Programmable Volume Control

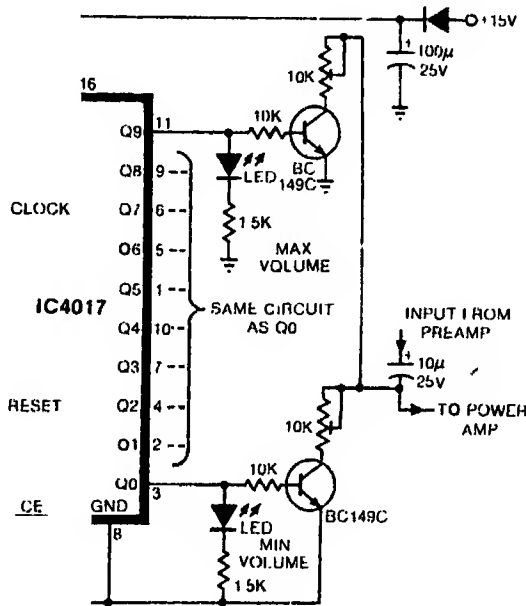
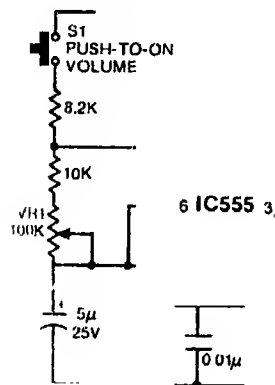
□ 'Programmable Volume Control' is really a very interesting idea, but it has the following limitations:

- (a) Thumbwheel switch is required to control the volume;
- (b) It has to memorise the truth table;
- (c) We cannot see the visual indication of the volume; and
- (d) 5V regulated power supply is required.

These problems can be solved with an additional facility such as a mute switch or we can say fast set to '0' volume. Only two push-to-on type switches are required (as shown in Fig.)

to control the volume.

We can mount the programmable volume control on front panel with visual indication
A.S. BAJWA
Kapurthala

easy to interface with a microcomputer kit.

Mr A.S. Bajwa has indeed suggested a good modification to my circuit idea. Now one can easily install it inside a radio, TV, cassette recorder, amplifier or any other audio equipment. However, the circuit described by me is
